Re: NEUMARK IRRIGATION SUPPLIES ADDITION

Re: Neumark Irrigation Supplies Building Addition, 811 Rankin Road NE, Grading and Drainage Plan

Based upon the information provided in your submittal received 12-15-04, the above referenced plan cannot be approved for Building Permit until the following comments are addressed:

DRAINAGE ANALYSIS FOR NEUMARK IRRIGATION SUPPLIES BUILDING ADDITION

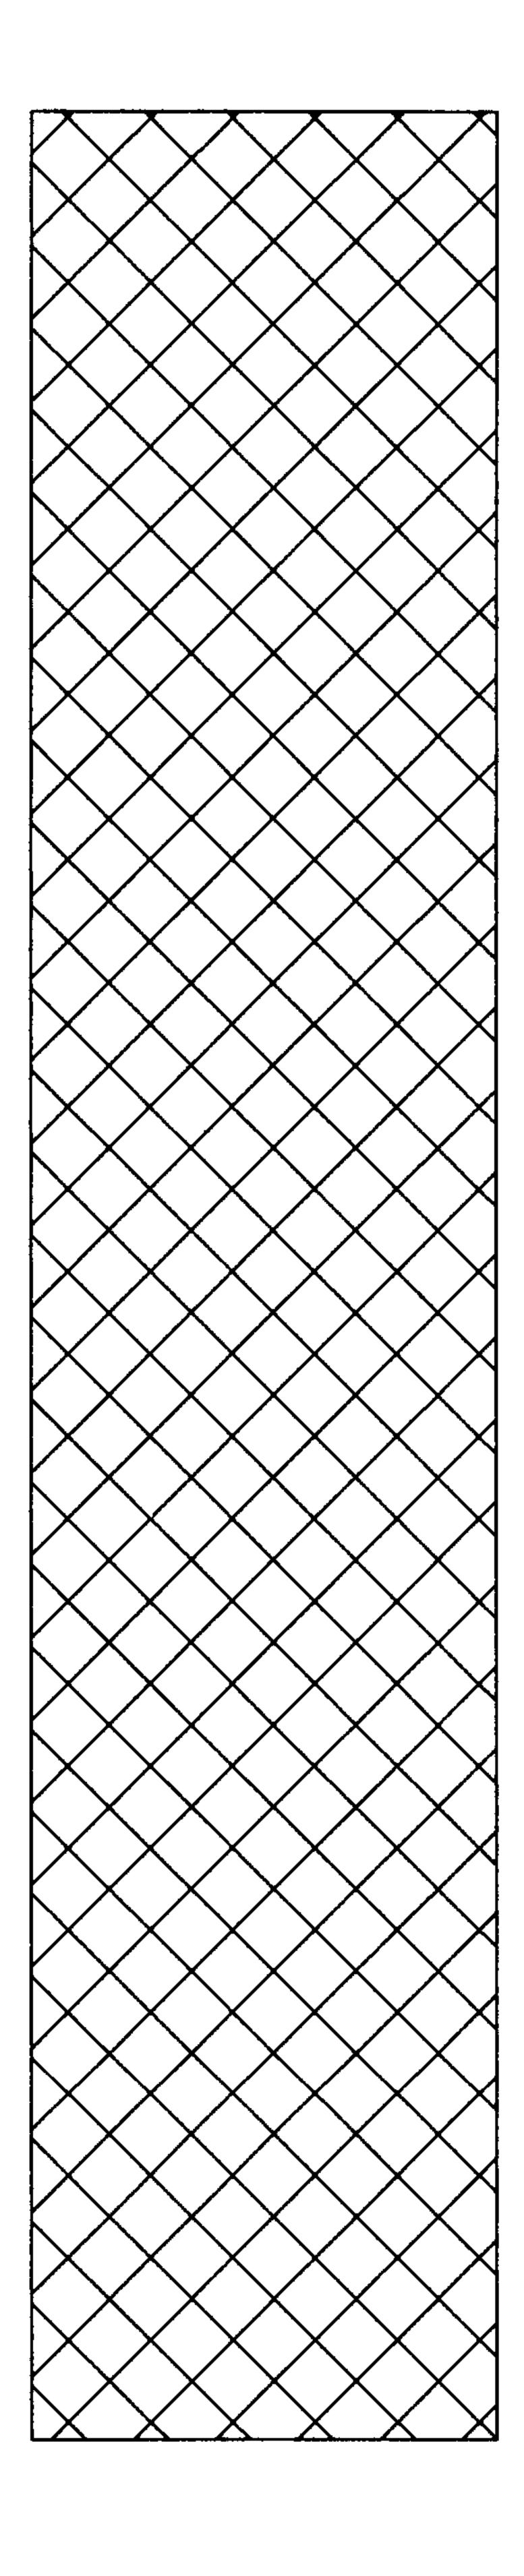
Exists flows that run to adjunct lot draino directed to the pond A Exists Show area w/no pawing "Water Hawest Pond!" not retention pord) Swall runout from sond Show detait of pond overflow?

GRADING AND DRAINAGE PLAN

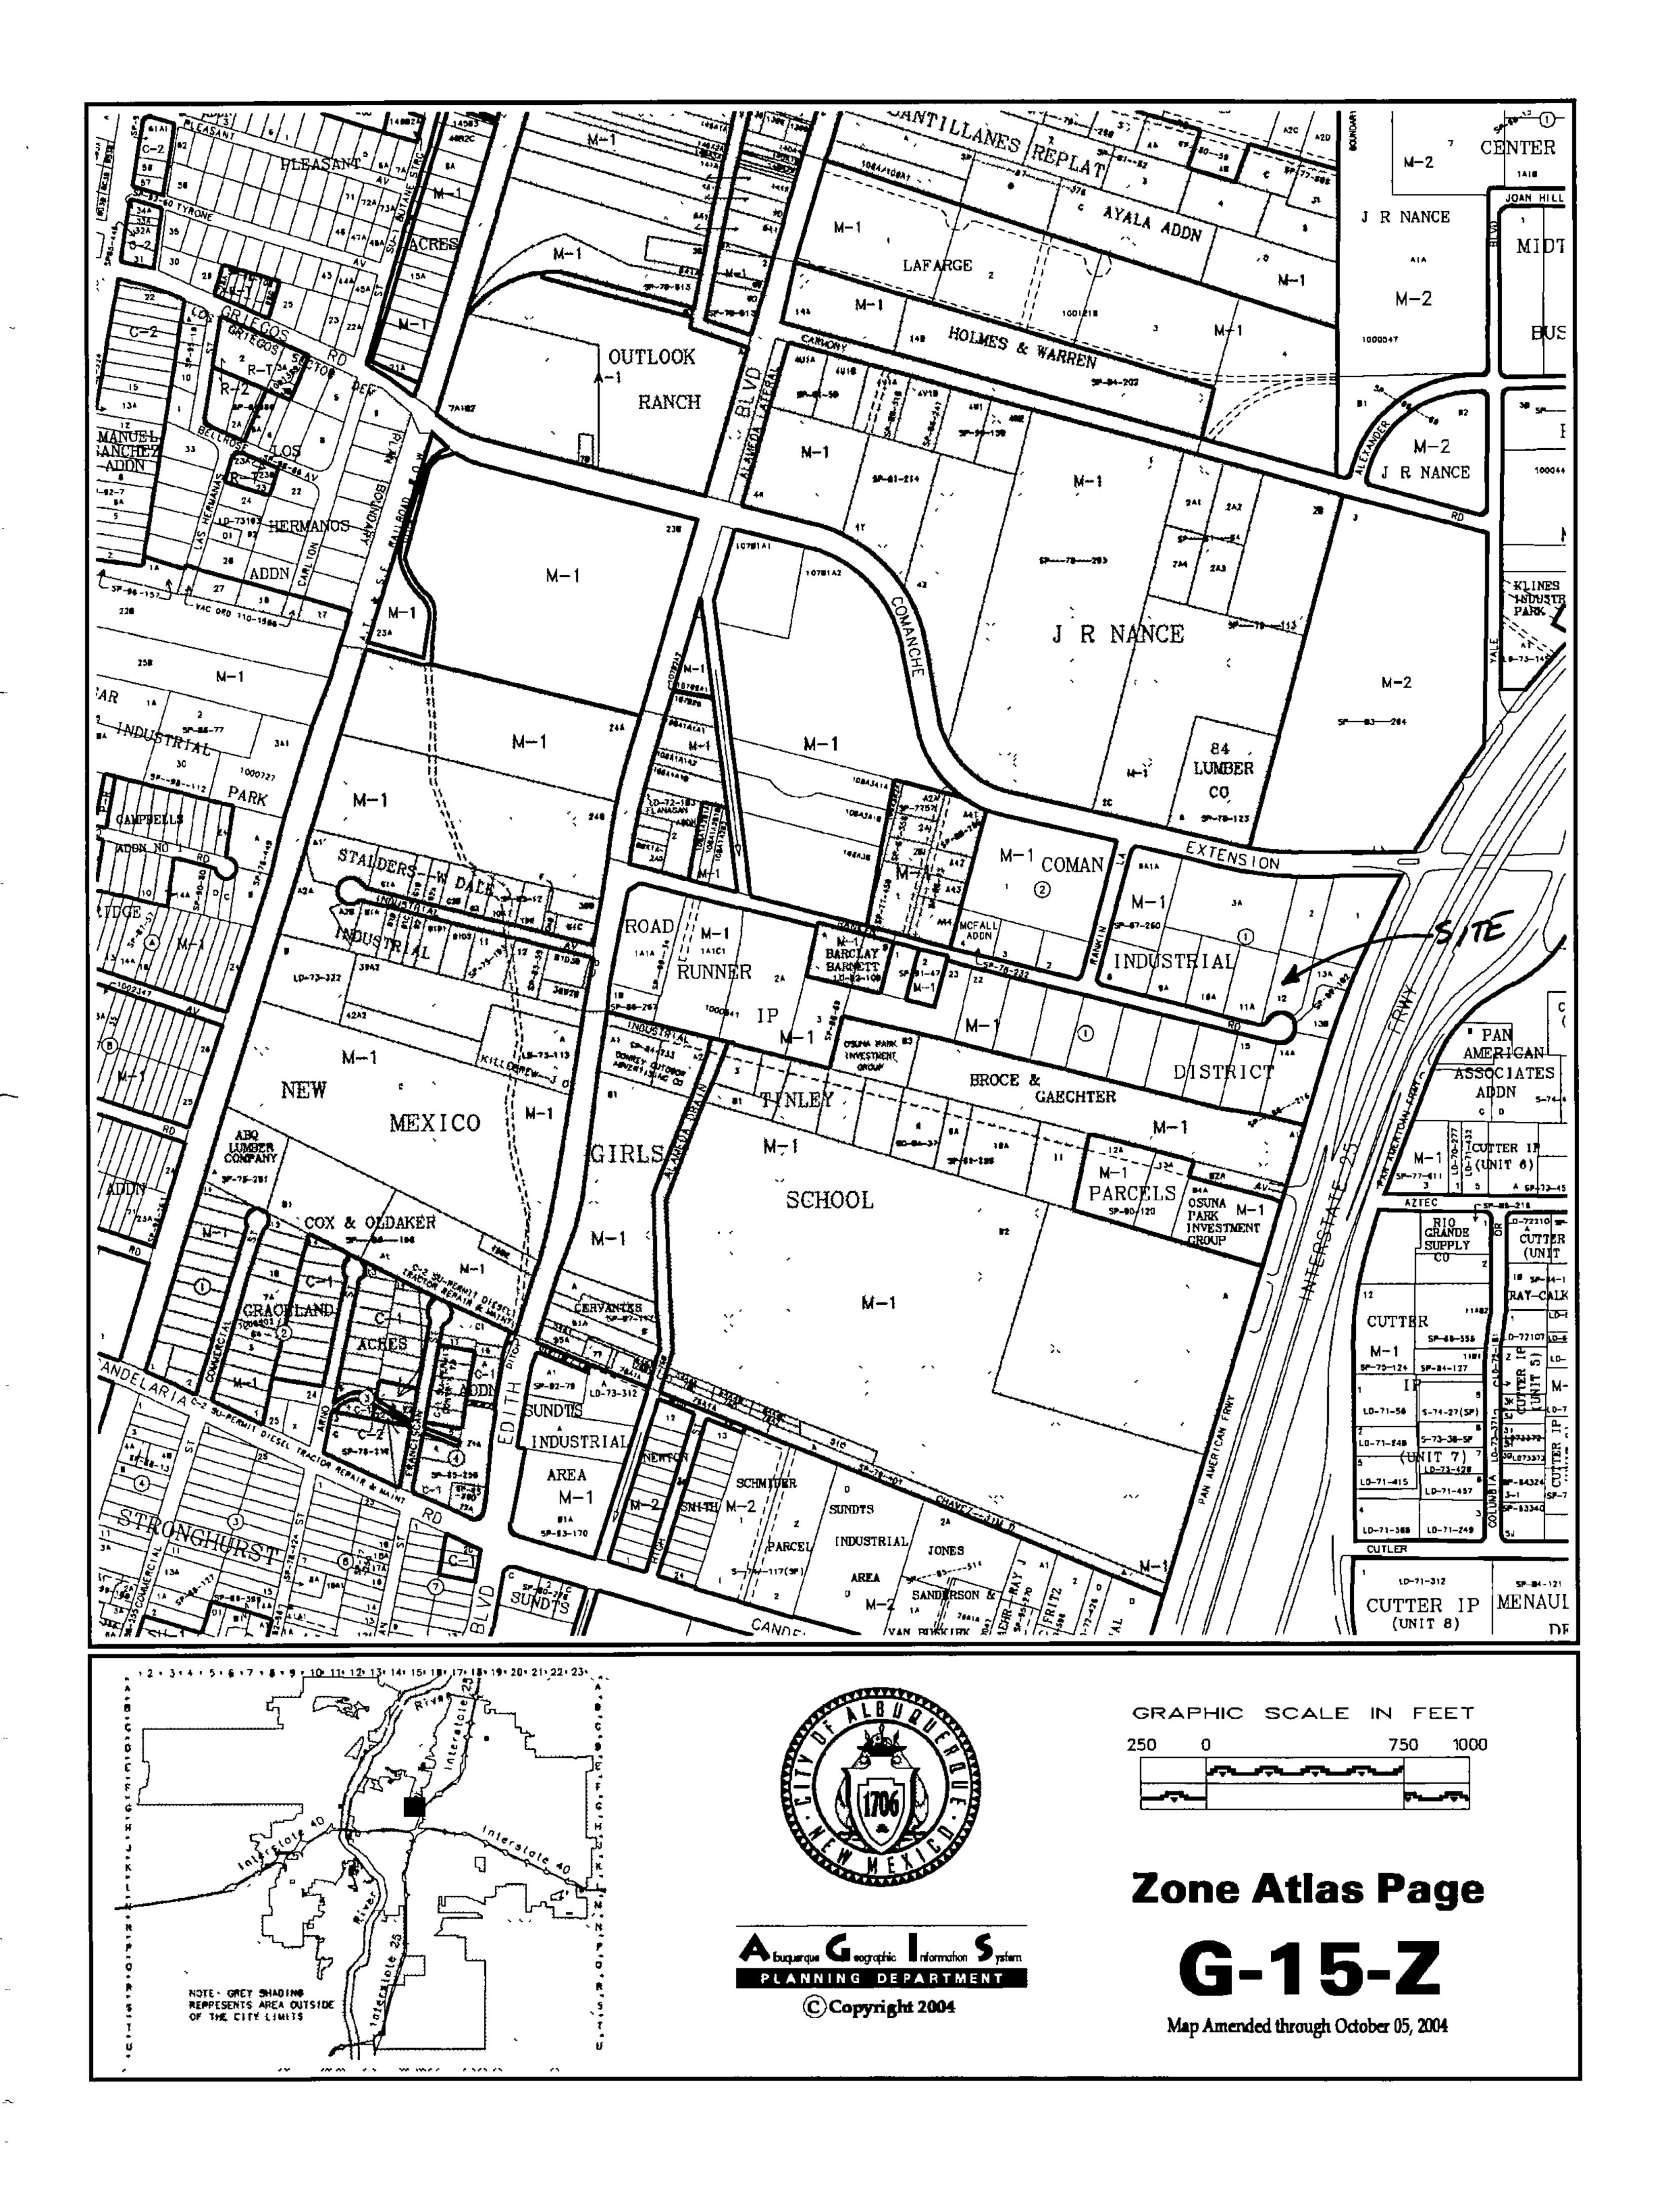
- 1. Direct all roof flows to the water harvesting pond.
- 2. Show which areas are paved and which are not.
- Albuquerque
- 3. Provide an overflow structure for the pond.
- 4. Show a detail of the pond overflow structure.

Check this plan: should have a water harvesting pond and a pond overflow detail
